Subject: Mt. Carmel Grove City Medical Center  
Development plan Amendment Application  
Control No.: 201603110014  
EMH&T Job No.: 2013-1538

We have summarized the comments received from City of Grove City on March 23, 2016 and provided our response. The plans have been updated to address the comments as follows:

MOUNT CARMEL  
Grove City  
Phase II  
Development Plan

**C1.0**

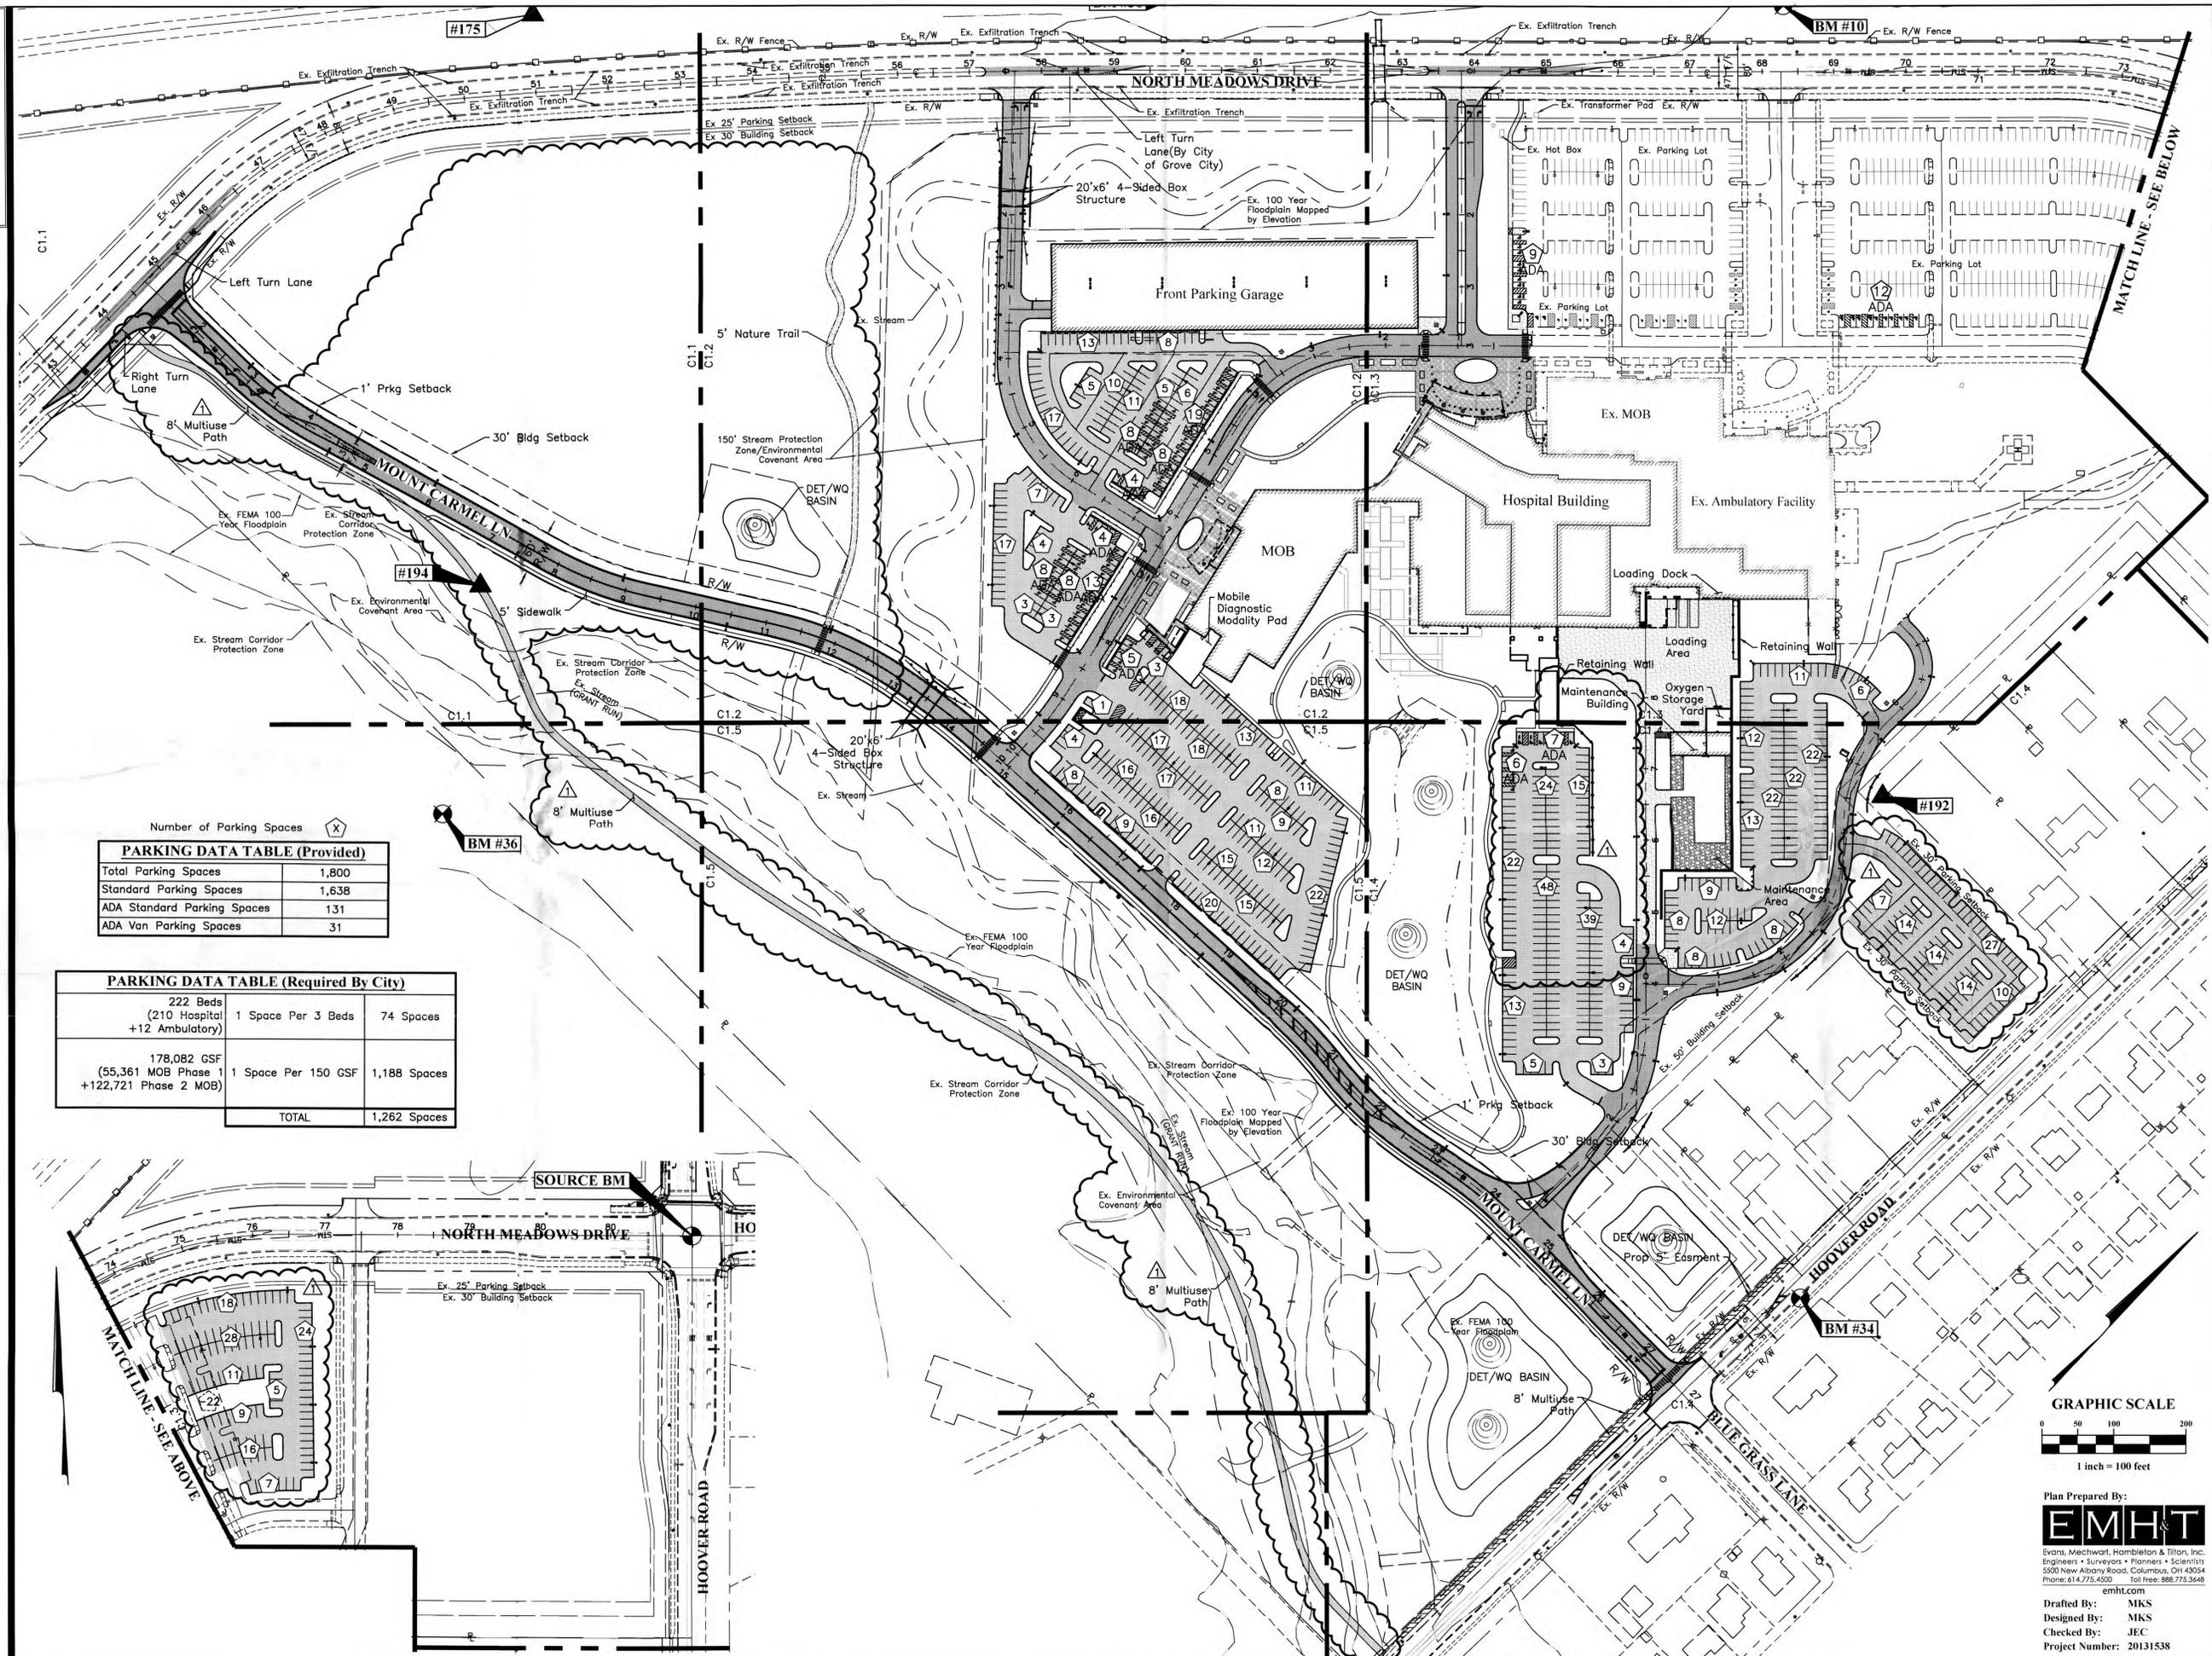
14. The overall site plan revision clouds do not include the grading changes proposed at the lot located SE of the Mt. Carmel Drive and North Meadows Drive intersection or the grading changes proposed for the lot SW of the Hoover Road and N. Meadows Drive intersection.

**Response: Additional clouds have been added to the sheets to reference all areas affected by the proposed amendments, even if no specific changes show up on a given sheet.**

**C1.4**

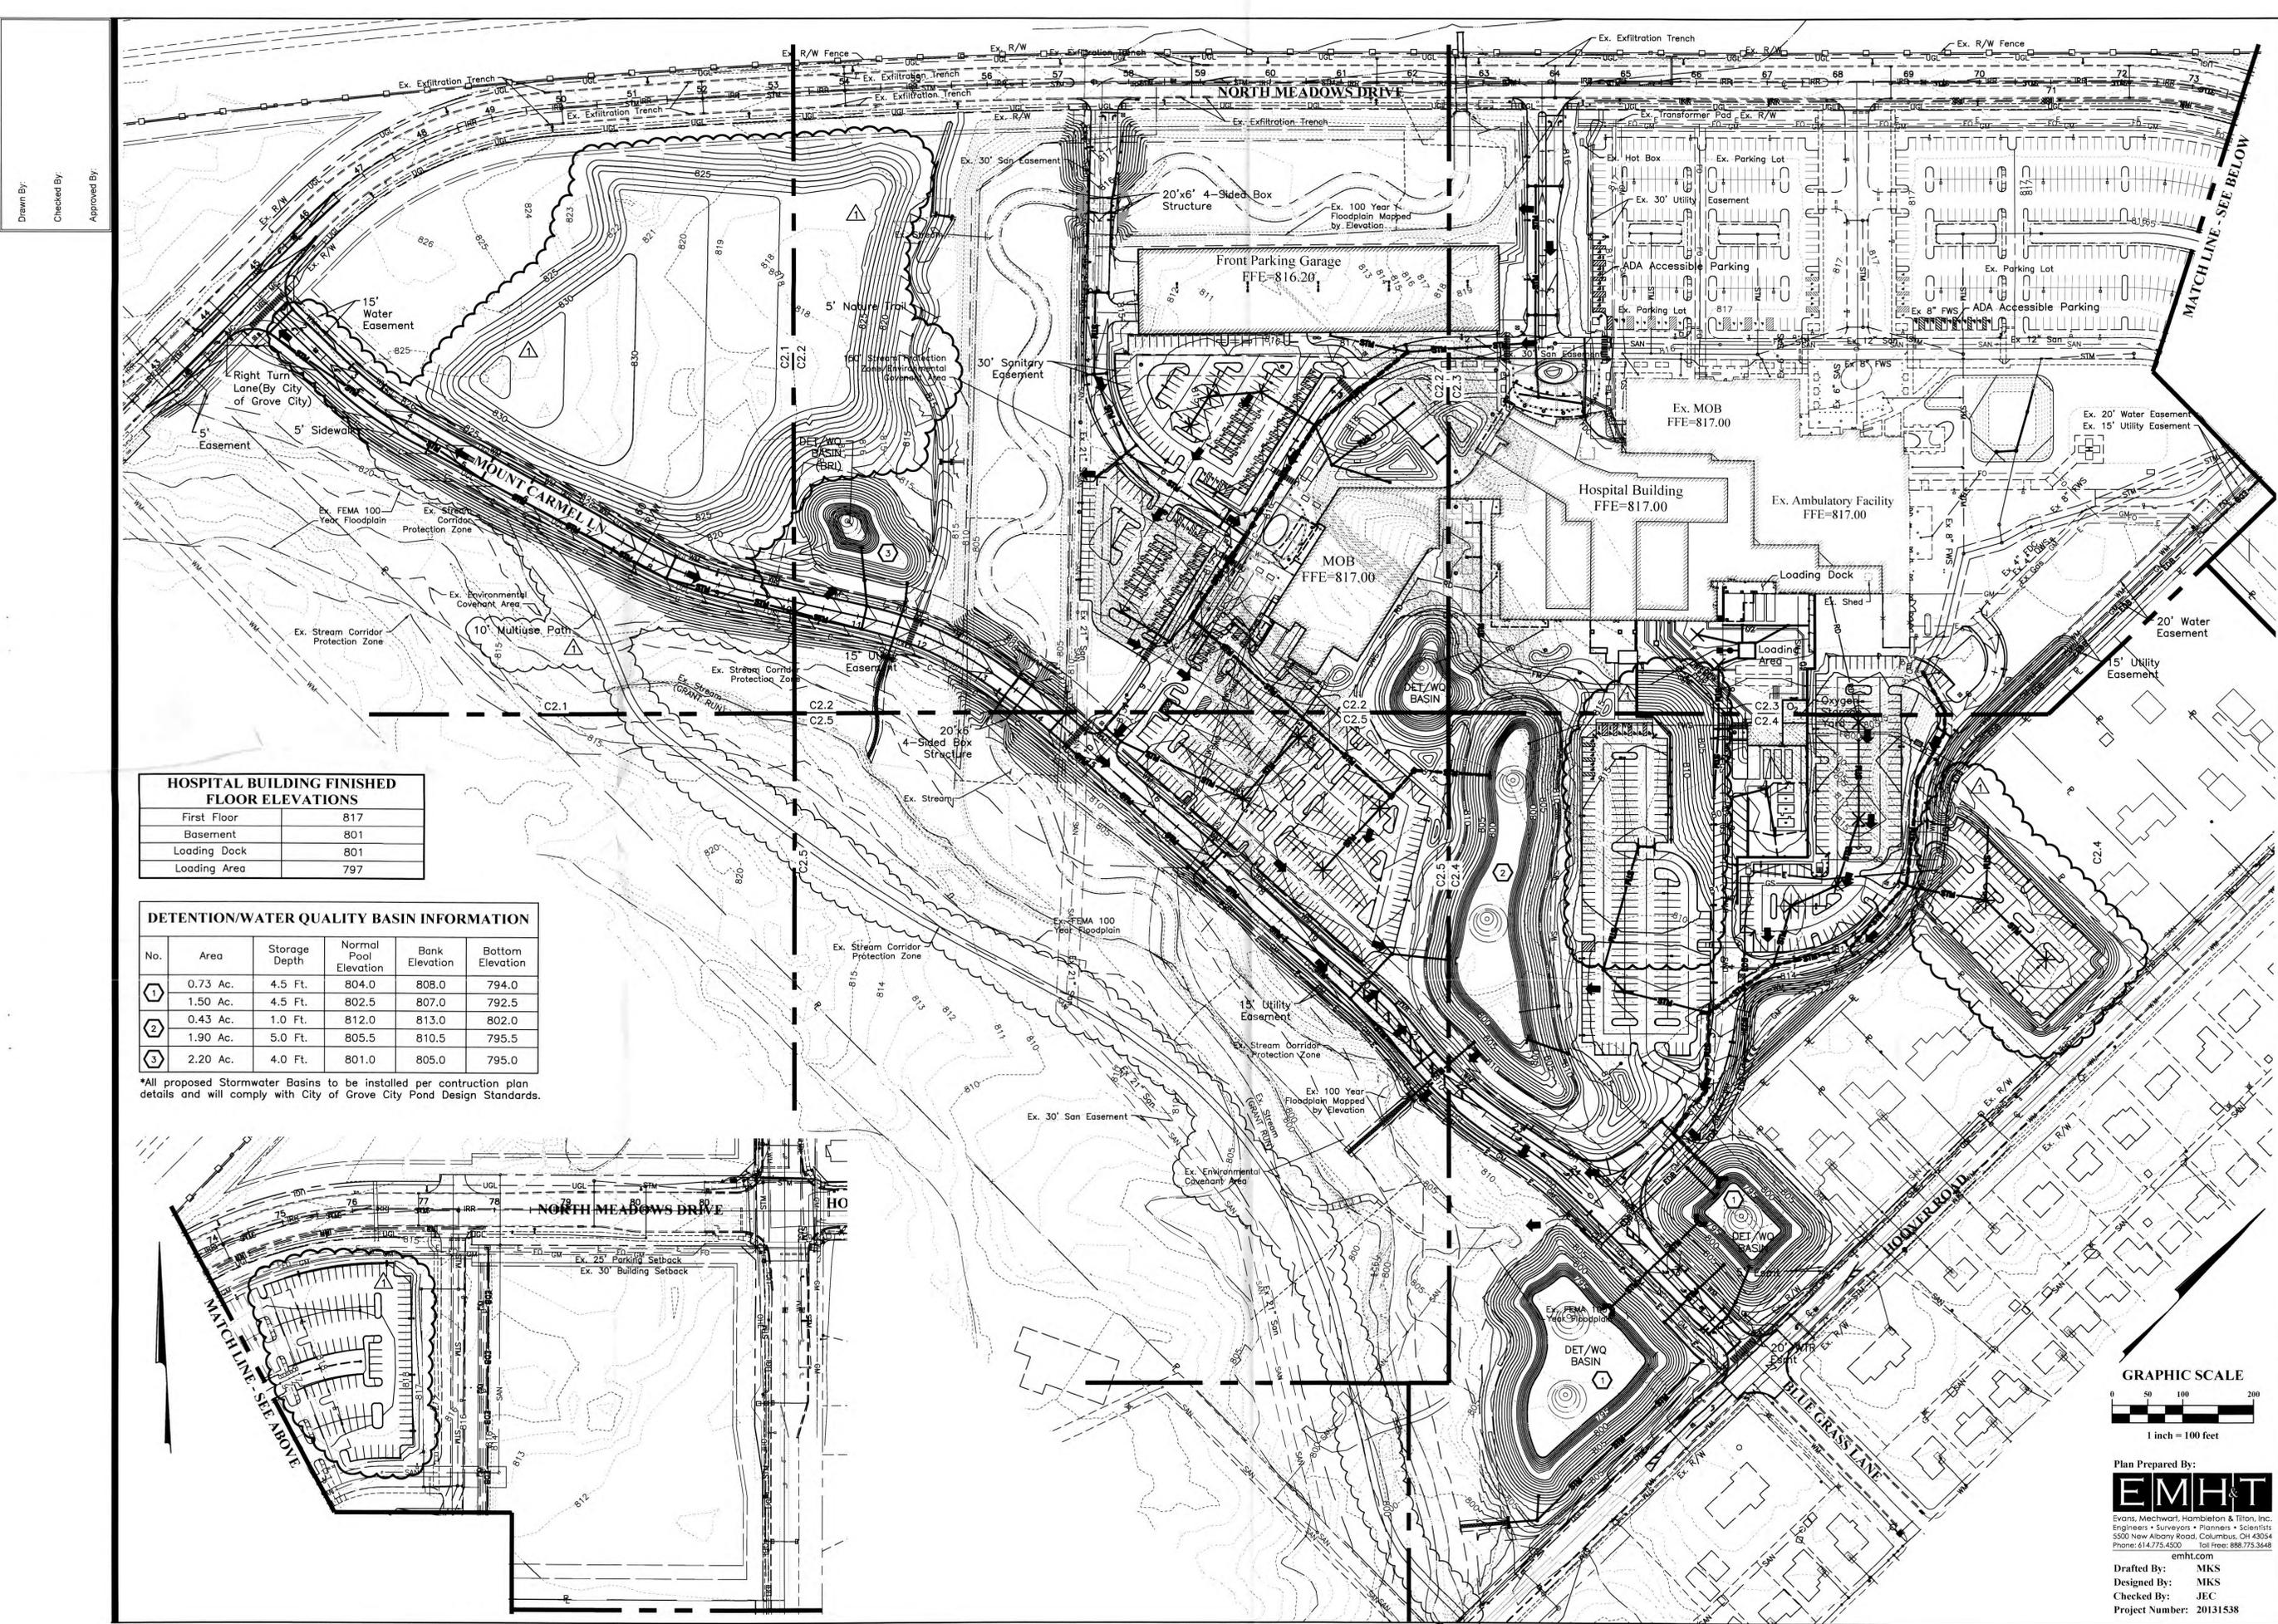
15. The multi-use path will require additional grading and drainage details as well as a standard pavement composition detail.

**Response: The multiuse path design will include a 10' wide pavement section based on Grove City Standard Drawing C-GC-80.**

**C2.0**

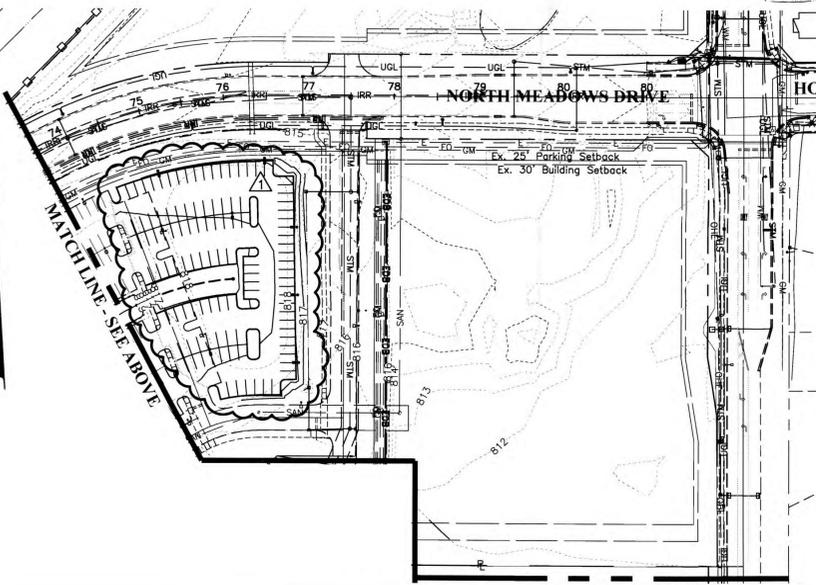
16. Recommend the grading for the lot at the SE corner of N. Meadows and Mt. Carmel Lane be limited to 5% slopes for the first 100' adjacent to each roadway. The grading shown is approximately 13% to 15% for the first 70' along each road frontage which will have the appearance of a soil stockpile instead of a natural part of the landscape. The steep grades will make it difficult to construct a normal safe grade for any future drives or walks which would be built on the lot to provide access to a future building development.

**Response: The Owner understands that the aesthetics of any future building improvements on the fill area will be subject to development standards in place at that time. No drives planned for future access to building sites are anticipated at steeper than a 5% grade.**

**C2.1**

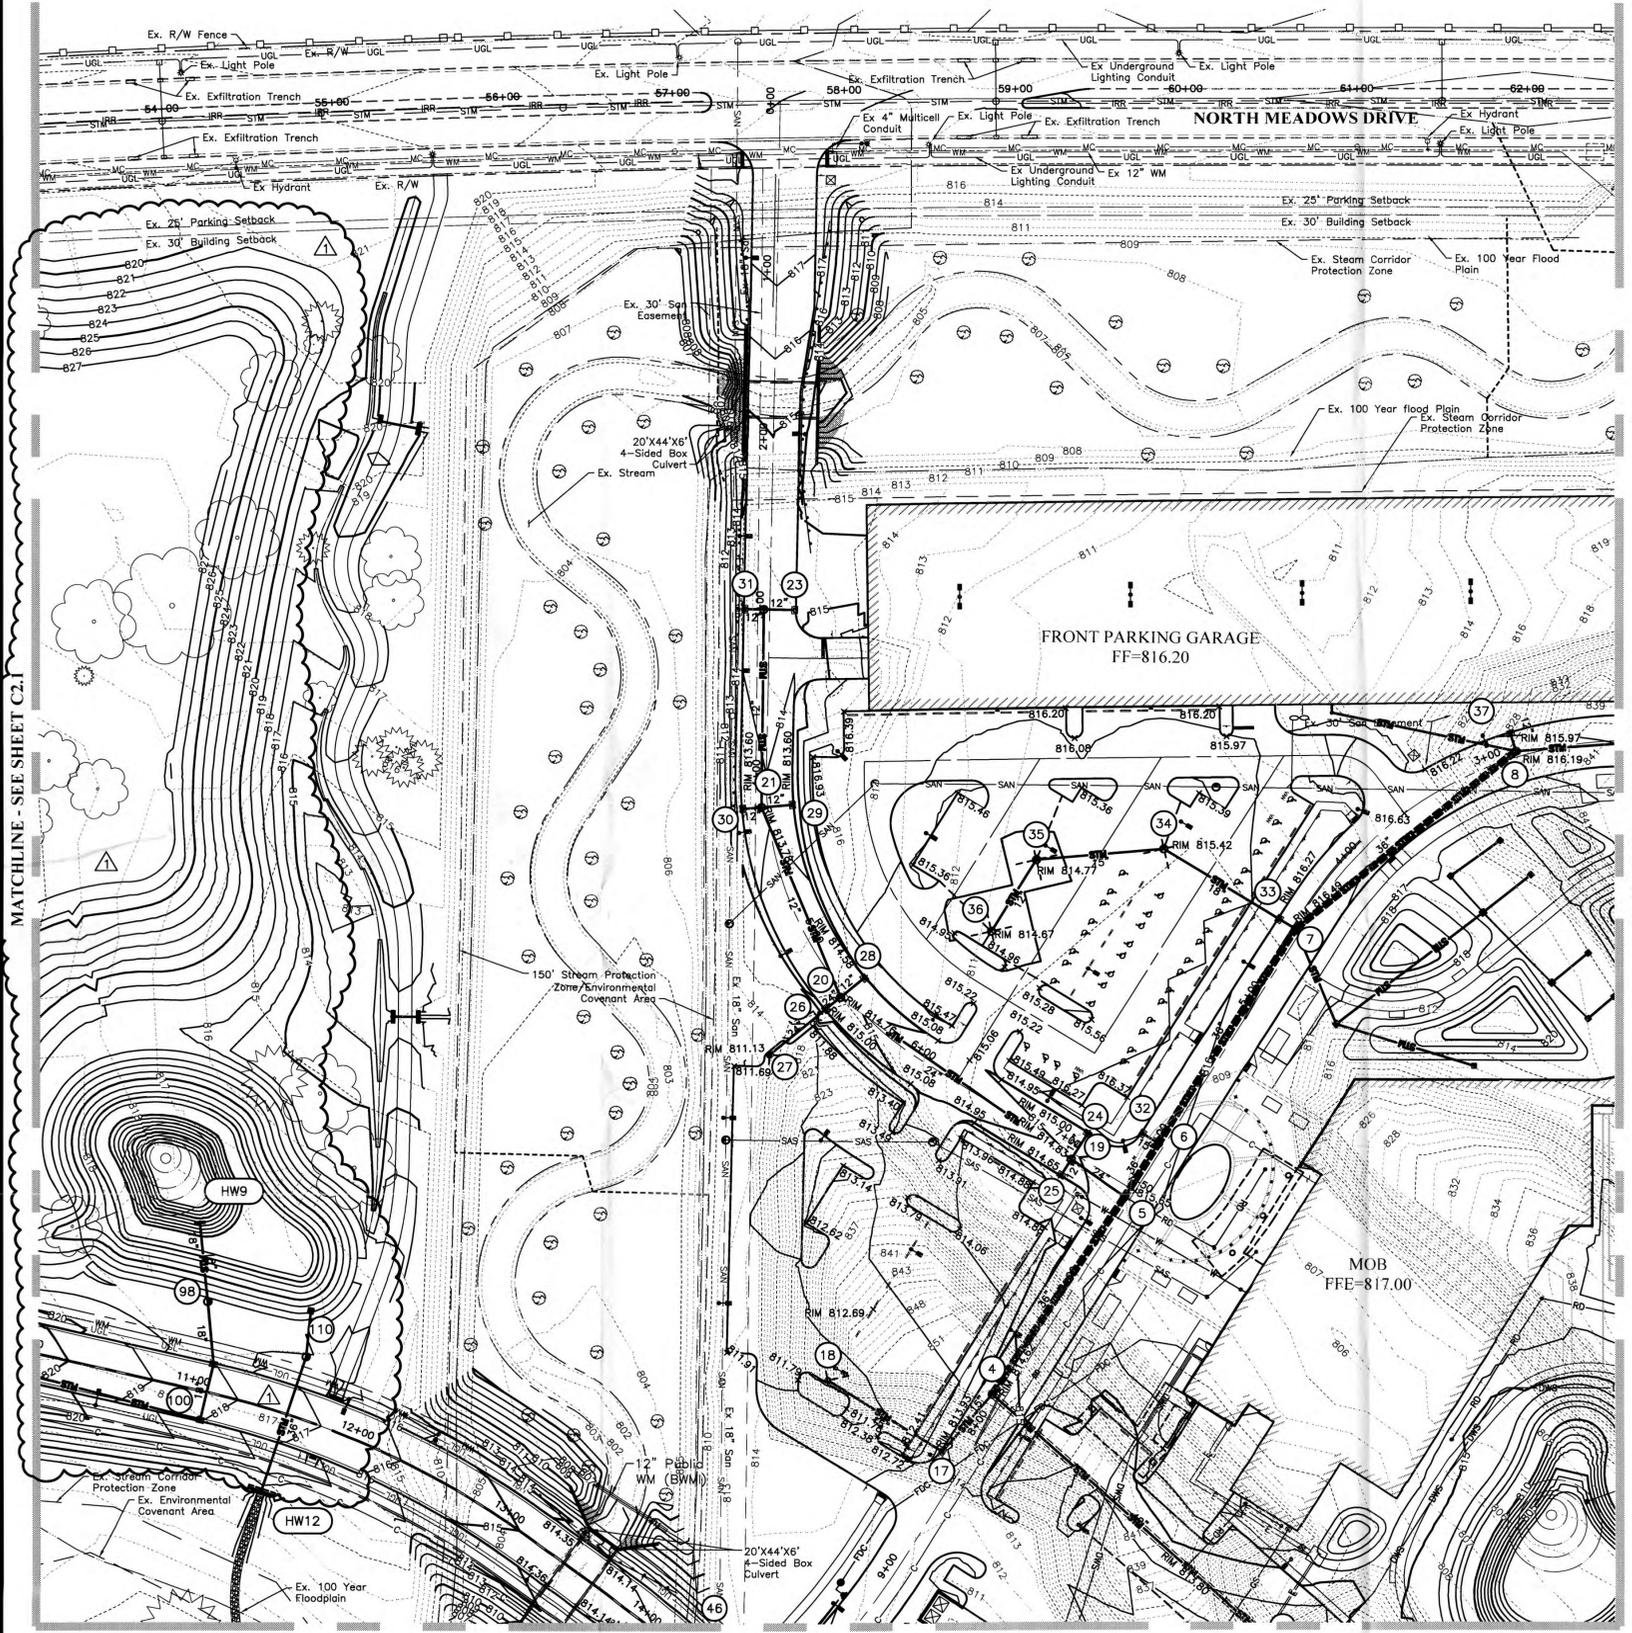
17. The lot grading for the proposed fill does not match the contours shown on Sheet C2.0. See comment 5 above. The contours shown on this sheet show a higher roadway along Mt. Carmel Lane which has not been submitted or approved.

**Response: Sheet C2.0 has been updated to match the grading shown on C2.1. The potential higher roadway is one of the changes being considered through this development plan amendment.**
